# Access Compliance Report

## Public Rights-of-Way

### (Curb Ramps)

Intersection ID: 25717	Main Street: WOODLEIGH_OAKS_DR	Cross Street: WOODMERE_CROSSING_LN	Location: W
ADA ID: A3C20978A19F	Ramp Type: Perp	Initial Pass/Fail: Fail	Overall Compliance: No
Severity Score: 10			
Codes/Mitigation Info/Possible Solution		Field Measurements/Component Compliance

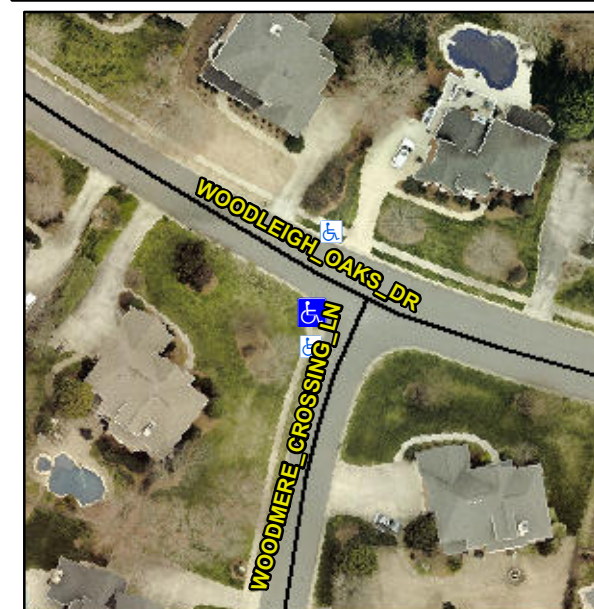
**Not Found, R304.5.1, R304.5.3**

Compliance	Description	Data	Compliance	Description	Data
N/A	Ramp Length (in)	94.0	Yes	Ramp Slope (%)	5.5
No	Ramp Width (in)	40.0	No	Ramp XSlope (%)	3.8
N/A	Flare Type LT	N/A	N/A	Flare Type RT	N/A
N/A	Flare Slope LT (%)	N/A	N/A	Flare Slope RT (%)	N/A
N/A	Flare Traversable LT?	N/A	N/A	Flare Traversable RT?	N/A
N/A	Landing Length (in)	N/A	N/A	DWS Provided?	N/A
N/A	Landing Width (in)	N/A	N/A	DWS Contrast?	N/A
N/A	Landing Slope (%)	N/A	N/A	DWS Length (in)	N/A
N/A	Landing X Slope (%)	N/A	N/A	DWS Full Width?	N/A
N/A	Landing Curb? (Y/N)	N/A	N/A	DWS Offset (in)	N/A
N/A	Shared Landing?	N/A			
N/A	Gutter Ponding?	N/A	N/A	Gutter Slope (%)	N/A
N/A	Gutter Lip Ht (in)	N/A	N/A	Gutter X Slope (%)	N/A
N/A	Painted X Walk1?	No	N/A	Painted X Walk2?	N/A
	X Walk 1 Direction	To NE		X Walk 2 Direction	N/A
N/A	X Walk 1 Width (in)	N/A	N/A	X Walk 2 Width (in)	N/A
	X Walk 1 Slope (%)	4.4		X Walk 2 Slope (%)	N/A
	X Walk 1 X Slope (%)	1.9		X Walk 2 X Slope (%)	N/A

**Remove & Replace Entire Ramp.**
